KEYSTONE XL PIPELINE PROJECT

0456-SD-P4-305.9-308-S

KEYSTONE XL PIPELINE PROJECT ROUTE VARIATION AUTHORIZATION FORM		
Date: <u>8/7/2013</u>	Tracking Number: <u>0456-SD-P4-305.9-308-S</u>	
Description: The primary reason for this CL reroute is to avoid 4 Continental Oil wellheads/lines currently crossed by the KXL line.	MP: <u>305.9</u> to <u>308.0</u>	
	Originated By: <u>Engineering</u>	
	Variation Form Attached: Yes <input checked="" type="checkbox"/> No <input type="checkbox"/>	
<u>TransCanada - Land</u> Tina Hall	Variation: Approved <input checked="" type="checkbox"/> Rejected <input type="checkbox"/>	
Comments:	<i>[Signature]</i> Date: <u>8/14/13</u>	
	If Rejected Why?	
<u>TransCanada - Engineering</u> Meera Kothari	Variation: Approved <input checked="" type="checkbox"/> Rejected <input type="checkbox"/>	
Comments:	<i>[Signature]</i> Date: <u>8/15/13</u>	
	If Rejected Why?	
<u>Exp - Engineering</u> Kevin McGlynn	Variation: Approved <input checked="" type="checkbox"/> Rejected <input type="checkbox"/>

KEYSTONE XL PROJECT
PROPOSED ROUTE VARIATION

DWG: XL-30-P-9299-A-CLRV SHEET: 1 of 1

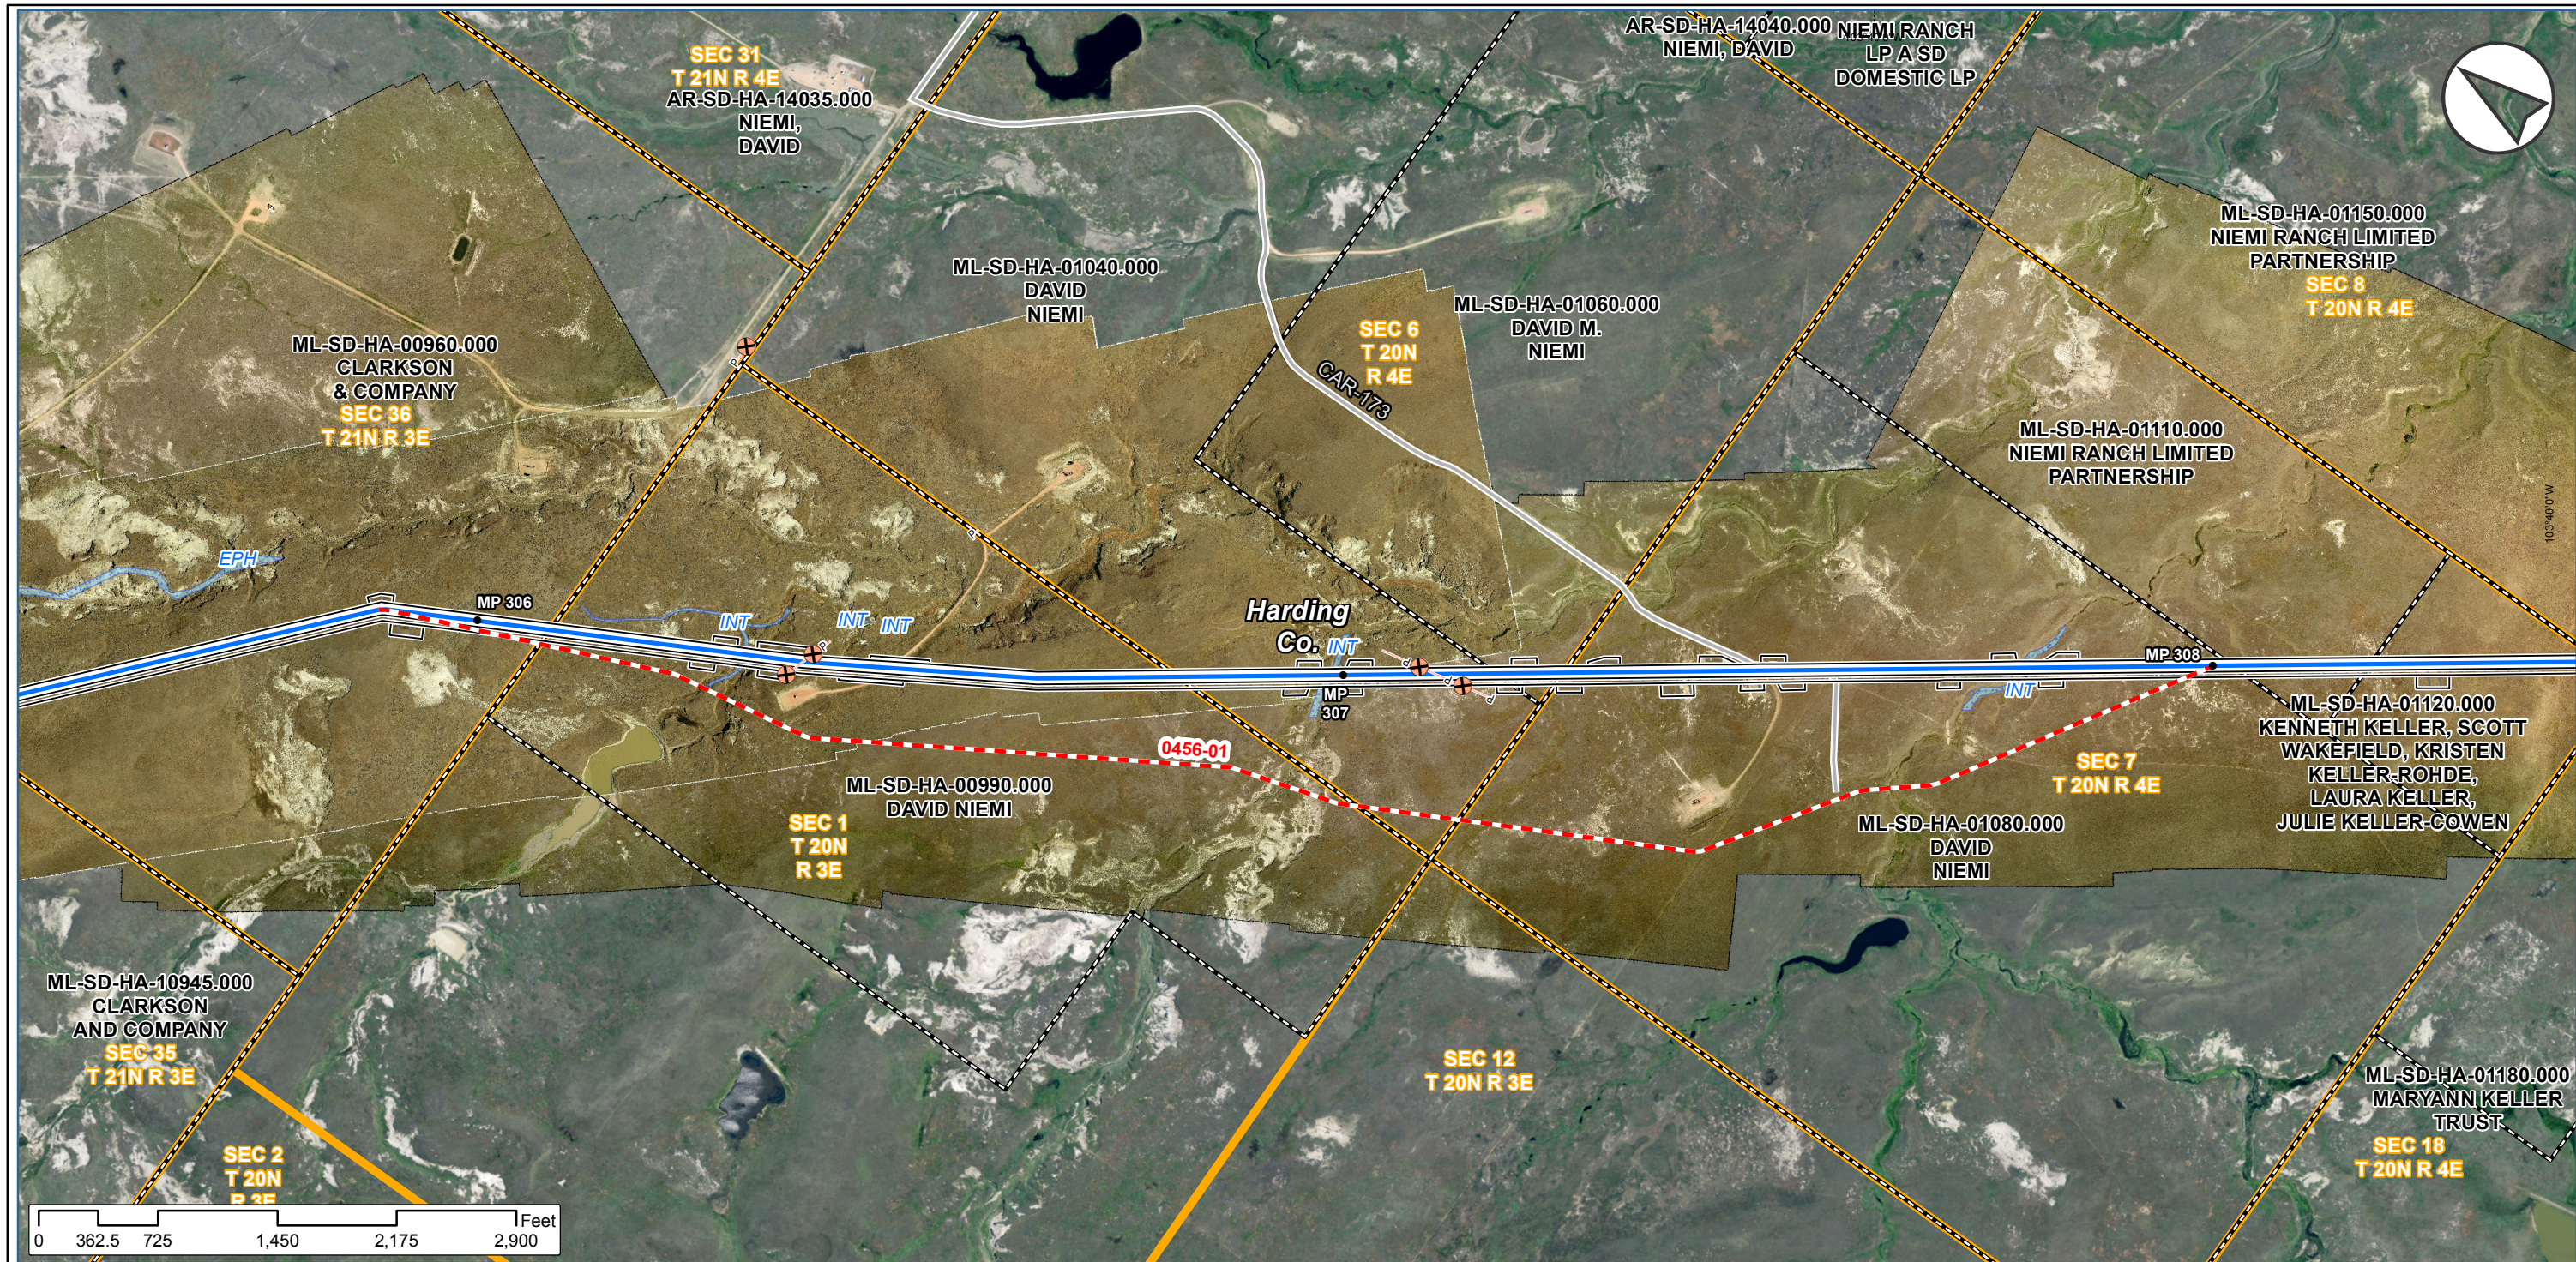
3	REASON FOR ROUTE VARIATION (Please include reason for route variation): The primary reason for this CL reroute is to avoid 4 Continental Oil wellheads/lines currently crossed by the KXL line. Route variation was field verified and civil surveyed. Proposed CL reroute is requested by Engineering.			
	DETAIL ROUTE VARIATION (Please describe route variation in detail): The reroute begins near MP 305.9 where it deviates from the current CL ~5° in the south direction. It continues in this direction for ~1,839 ft. From there, it angles ~13° south and extends for ~918 ft. prior to continuing in the southeast direction for ~2,554 ft. It then turns south again for ~682 ft. before turning slightly southeast for ~2,190 ft. The proposed reroute continues turning southeast and extends for ~1,054 ft. It then PIs in the east direction, thus straightening the line for a creek crossing. It extends in this direction for ~416 ft. before making a final turn southeasterly towards the current CL. It will extend in this direction ~1,861 ft. before it reconnects with the current CL near MP 308.0. <u>4 Tracts Impacted:</u> ML-SD-HA-00960.000 (Clarkson & Company) ML-SD-HA-00990.000 (David Niemi) ML-SD-HA-01040.000 (David Niemi) ML-SD-HA-01080.000 (David Niemi) ML-SD-HA-01060.000 (David M. Niemi) - CL offline, still will have CAR-173 impact.

ADDITIONAL IMPACTS (Please include any additional impacts which may affect cost; crossings, induction bends, etc.): The majority of the proposed route variation will need to be environmentally surveyed.			
	Is there an increase/decrease in the number of crossings? Yes <input checked="" type="checkbox"/> No <input type="checkbox"/> If yes, please list: <input type="text" value="Proposed reroute avoids 4 Continental oil lines/wellheads."/>			
	COST ANALYSIS (costs incurred or saved from the route variation)			
	Additional length of route realignment:	384 ft.	\$ 138,314.96	\$ 360/ft
	Additional length of side-hill construction:	<input type="text"/> ft.	\$ -	\$ 19/ft
	Additional length of wetland construction:	<input type="text"/> ft.	\$ -	\$ 195/ft
	Additional bore length (Road, RR):	<input type="text"/> ft.	\$ -	\$ 540/ft
	Additional foreign line/pipeline crossings:	-4 EA	\$ (120,000.00)	\$ 30,000/EA
